Re: NCIRT Review and USACE Approval of the Hogan Creek Mitigation Plan (SAW-2011-02268)

SUBJECT: NCIRT Comments During 30-day Mitigation Plan Review

NCEEP Project Name: Hogan Creek Mitigation Project, Surry County, NC

2 CONSTRUCTED RIFFLE
D1 NTS

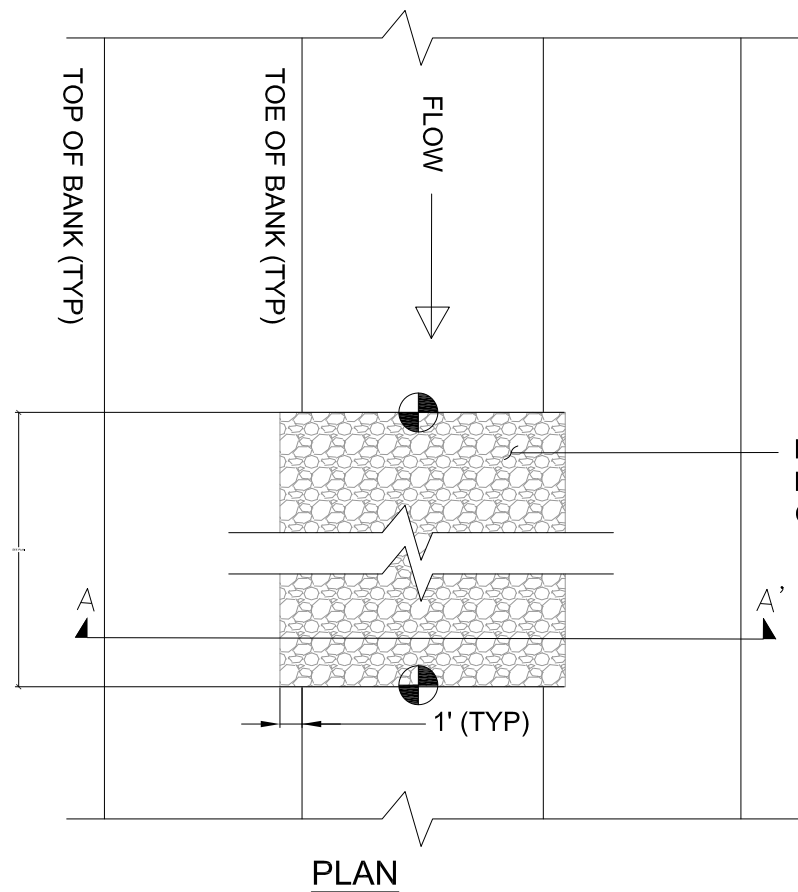
3. Proposed riffles should be constructed utilizing local material salvaged from the abandoned stream reaches. Confirmation was provided by Julie Cahill with NCEEP that local material from abandoned reaches will be utilized in the constructed riffles.

1. Travis Wilson, NCWRC, December 22, 2011: Significant portions of this project show the use of constructed riffles, if possible utilize local material salvaged from the abandoned stream reaches. My observation of the use of angular quarried material is: larger stone tends to form aquatic barriers at normal and low flow periods, and smaller quarried stone quickly becomes imbedded. Both resulting in sub-optimal habitat conditions.

NCEEP Response: This is addressing Travis Wilson comment on 12/22/11 - Local material from abandoned stream reaches will be utilized.
